**CHANGE ORDER NUMBER ONE(6)**

Project: Pct. 2 Yuma Avenue Extension Project

OWNER: Hidalgo County  
 OWNER'S CONTRACT NO: C-16-281-11-15

**YUMA AVE.  
PAVEMENT MARKINGS  
STA. 12+64 TO STA. 21+00**

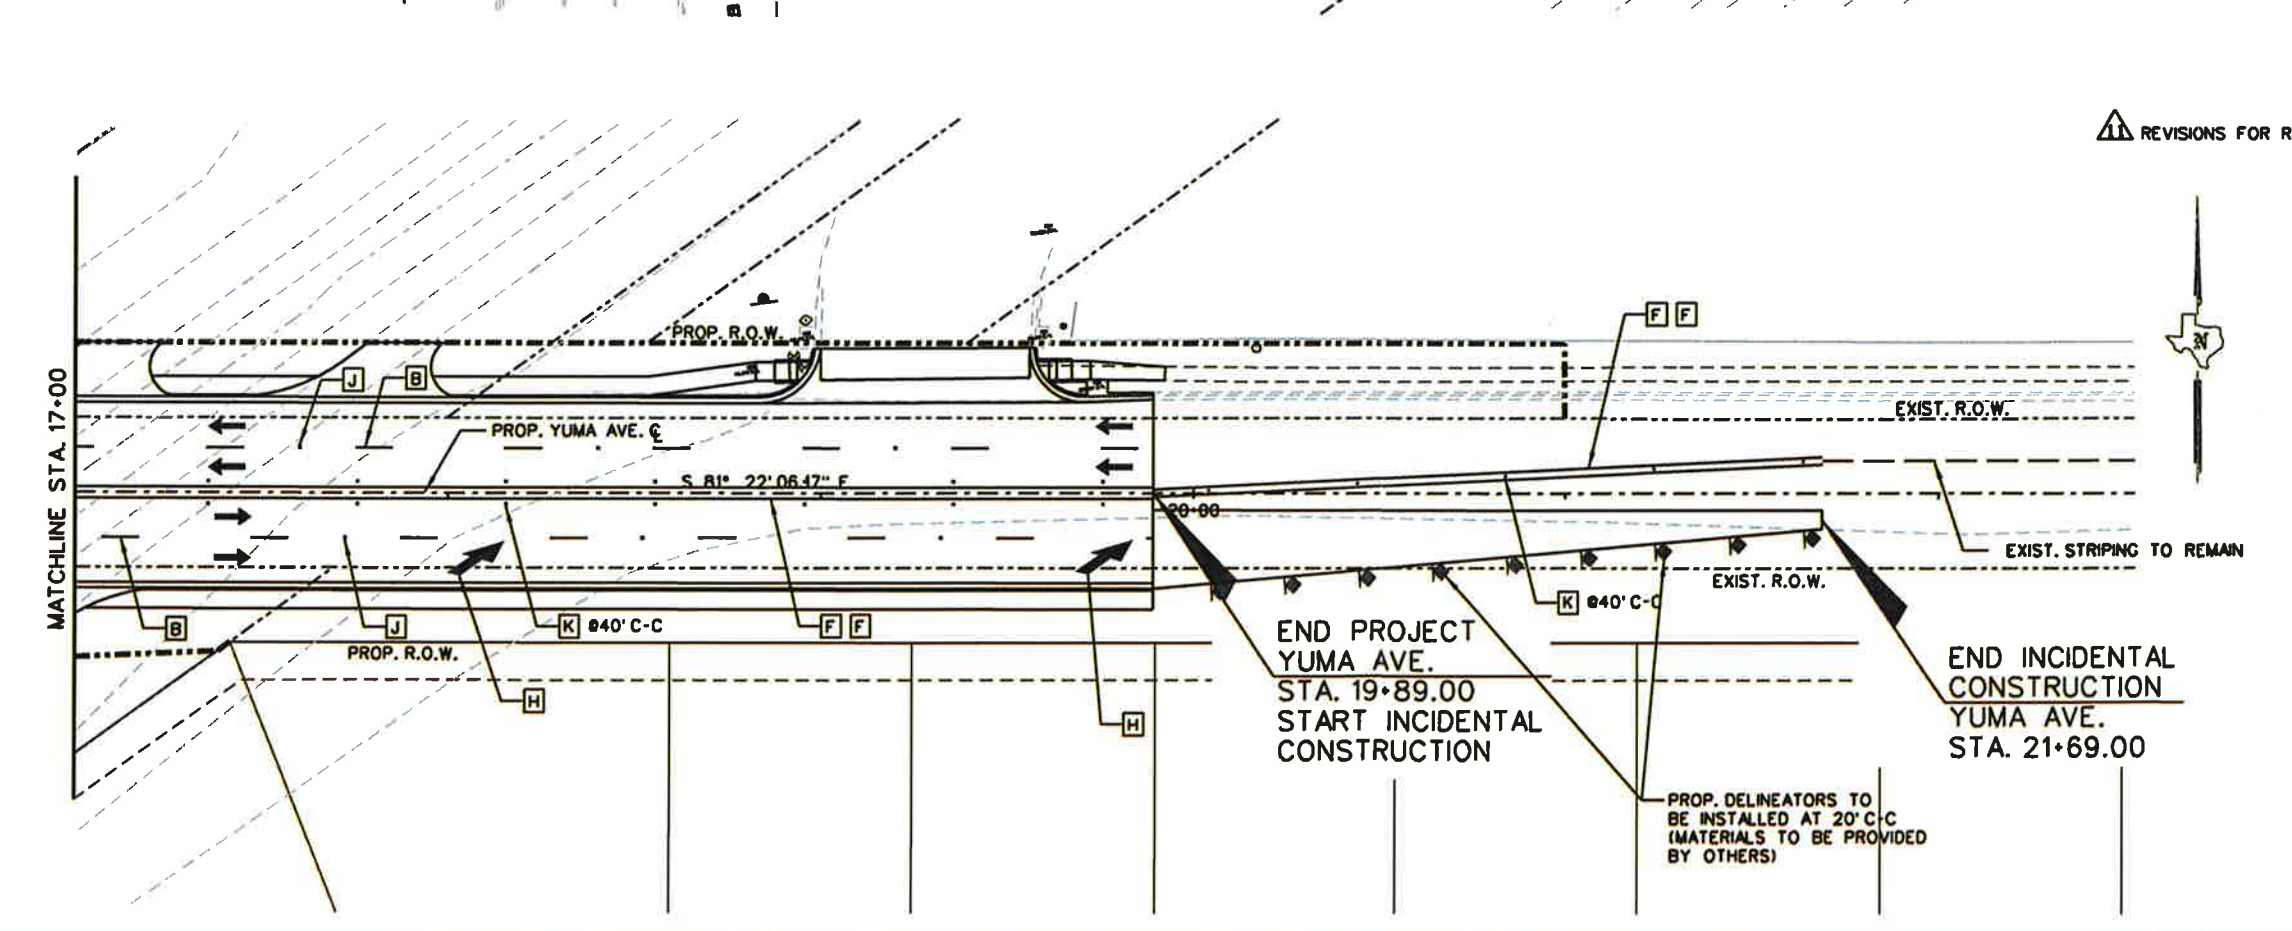
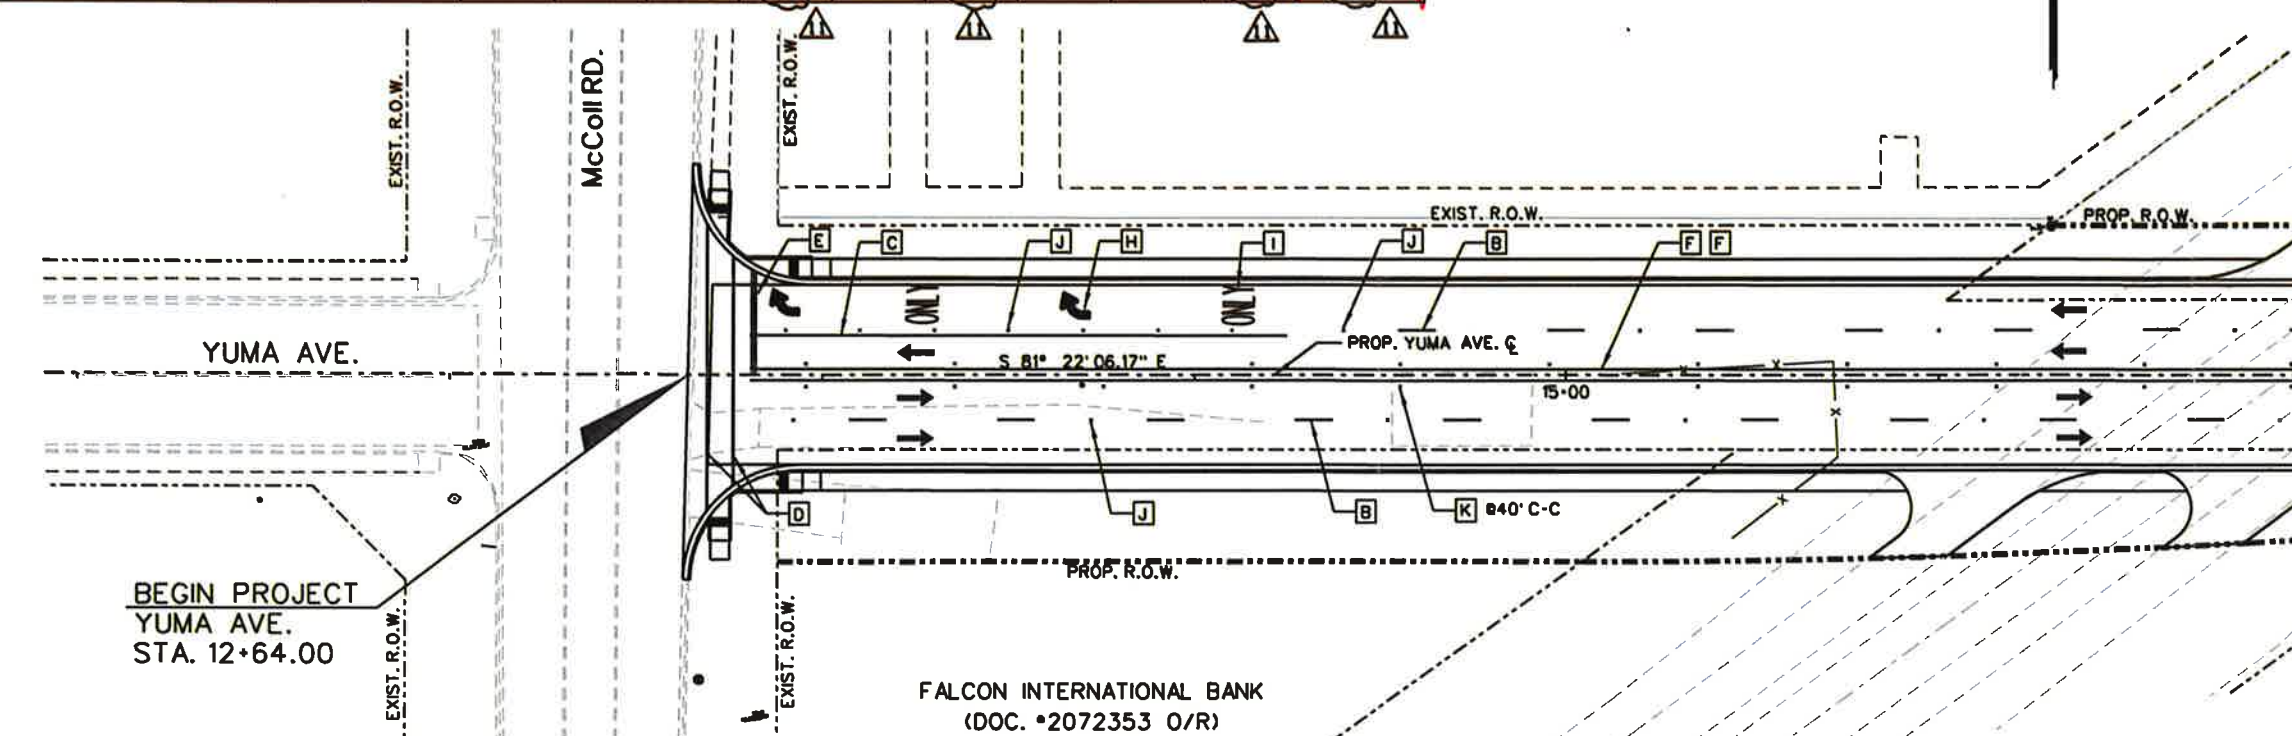
- Description:
1. Additional 666-6315 RE W/RET REQ TY 1 (Y)4"(SLD)(100MIL) 360 LF @ \$1.00 = \$360.00
  2. Additional 668-6019 PREFAB PAV MARK TY B (W)(ARROW) 2 EA @ \$295.00 = \$590.00
  3. Additional REFL PAV MARKR TY II-A-A 5 EA @ \$4.00 = \$20.00
  - 4.

REVISIONS FOR RFI NO. 11

The pavement markings layout along with the tie into existing Yuma is being reviewed by our traffic section. I should have a response by the end of the day. There is concern for merge and shift condition, specifically at night, for East bound travelers of Yuma. Once everything checks out, we will respond accordingly.

Please see attached PDF for revised pavement markings layout. After completed, please notify David or myself so we can meet for a walk through, then open roadway to traffic I am available anytime today and tomorrow.
